Access Compliance Report

Public Rights-of-Way

(Pedestrian Signals)

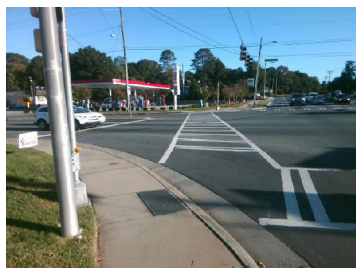
PROW/ADA: R406.2

Compliance	Description	Data	Compliance	Description	Data
	Button Count	Button2	N/A	Distant to Additional Button (in)	N/A
	Additional Button Present?	No		Additional Button ID	N/A
N/A	Signal Buttons Required?	N/A	N/A	Additional Ped Posts Required	N/A
	How Many Ped Street Xings?	2		Located In An Island/Median?	No
N/A	B 1 Sign Present?	Yes	N/A	B 2 Sign Present?	Yes
Yes	B 1 Sign Purpose?	Yes	Yes	B 2 Sign Purpose?	Yes
Yes	B 1 Sign Lettering & Contrast?	Yes	Yes	B 2 Sign Lettering & Contrast?	Yes
Yes	B 1 Parallel To XWalk?	Yes	Yes	B 2 Parallel To XWalk?	Yes
Yes	B 1 PAR to Button?	Yes	Yes	B 2 PAR to Button?	Yes
Yes	B 1 PAR to XWalk?	Yes	Yes	B 2 PAR to XWalk?	Yes
Yes	B 1 Clear Floor Space?	Yes	Yes	B 2 Clear Floor Space?	Yes
N/A	B 1 FWD Approach?	Yes	N/A	B 2 FWD Approach?	Yes
N/A	B 1 FWD Approach Constrained?	No	N/A	B 2 FWD Approach Constrained?	No
No	B 1 FWD Approach Reach (in)	5.0	No	B 2 FWD Approach Reach (in)	5.0

N/A	B 1 FWD Approach Width (in)	N/A	N/A	B 2 FWD Approach Width (in)	N/A
N/A	B 1 FWD Approach Obstruction?	Yes	N/A	B 2 FWD Approach Obstruction?	Yes
N/A	B 1 FWD Approach Obstruction Dist (in)	2.0	N/A	B 2 FWD Approach ObstructionDist (in)	2.0
N/A	B 1 PARA Approach?	Yes	N/A	B 2 PARA Approach?	Yes
N/A	B 1 PARA Approach Constrained?	No	N/A	B 2 PARA Approach Constrained?	No
Yes	B 1 PARA Approach Reach (in)	5.0	Yes	B 2 PARA Approach Reach (in)	5.0
N/A	B 1 PARA Approach Width (in)	N/A	N/A	B 2 PARA Approach Width (in)	N/A
N/A	B 1 PARA Approach Obstruction?	Yes	N/A	B 2 PARA Approach Obstruction?	Yes
N/A	B 1 PARA Approach Obstruction Dist (in)	2.0	N/A	B 2 PARA Approach ObstructionDist (in)	2.0
Yes	B 1 Clear Floor Space Slope (%)	2.0	Yes	B 2 Clear Floor Space Slope (%)	2.6
Yes	B 1 Clear Floor Space XSlope (%)	1.6	Yes	B 2 Clear Floor Space XSlope (%)	1.6
N/A	B 1 PAR Slope (%)	2.0	N/A	B 2 PAR Slope (%)	7.6
Yes	B 1 Height (in)	39.0	Yes	B 2 Height (in)	39.0

Possible Solutions: Provide Push Button Extension.
